BCC POLE INSTALLATION (ABC MAINS) 078521	
		BCC POLE INSTALLATION (BARE MAINS) 078518	
REFERENCE DRAWINGS			
DO NOT SCALE DIMENSIONS IN MILLIMETRES		AUTHORISED W. Isley	
DRAWN C.R.T.		MAINS DEVELOPMENT MANAGER 13-02-96	
DATE 29-02-95		A4 078520 E	
CH'D C.R.T.		SHEET No 1 OF 1 SHEETS

OVERHEAD CONSTRUCTION
COMMUNICATION CABLE INSTALLATION
NEAR SERVICE MAINS

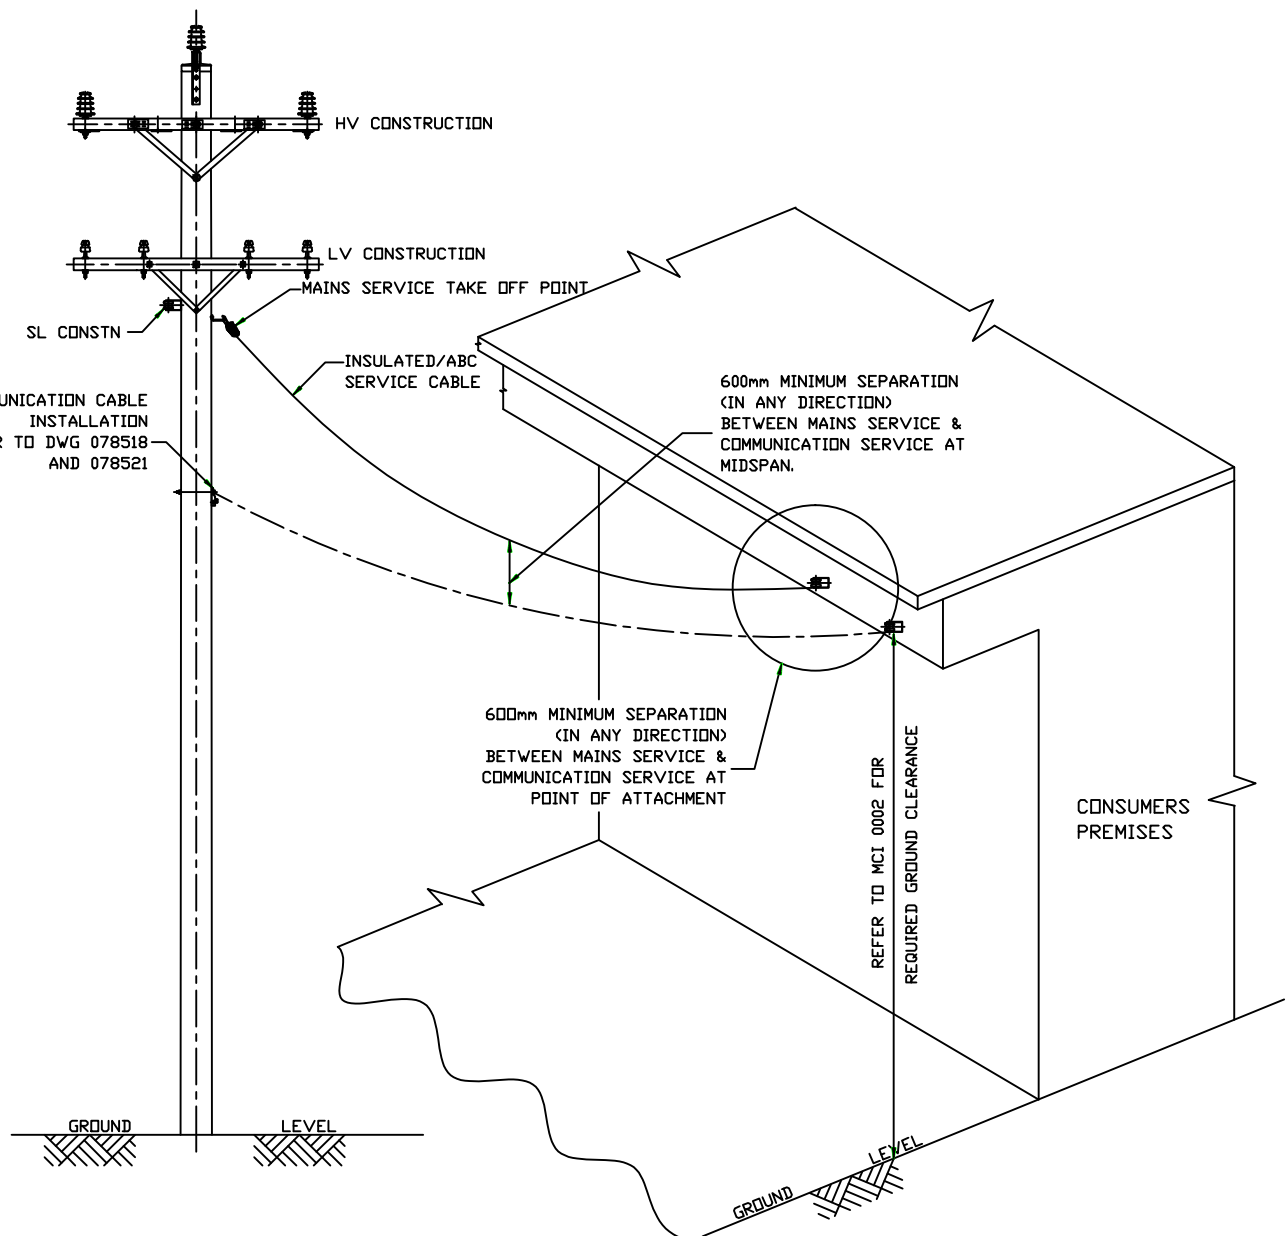
AMENDMENTS	
A	ORIGINAL ISSUE
B	DR'N C.R.T.
	CH'D C.R.T.
	DATE 08-02-96
	JR Nd930208
BCC WAS BBCC.	
C	SED C.H.B.
	DR'N RVL
	CH'D
	DATE 10-10-05
MIDSPAN SEPARATION WAS 150MM MIN. P OF A SEPARATION WAS 300MM MIN.	
D	CDA
	DR'N GSF
	CH'D GSF
	DATE 22-4-09
NOTE 1 ADDED. MIN CLEARANCE INCREASED TO 3M. SIZE WAS A2P.	
E	DSM GSF
	DR'N SM
	CH'D BH
	DATE 25-01-18
CHANGED TERMINOLOGY. REMOVED NOTE 1. CHANGED GROUND CLEARANCE REFERENCE.	
MAM B.Hellyer
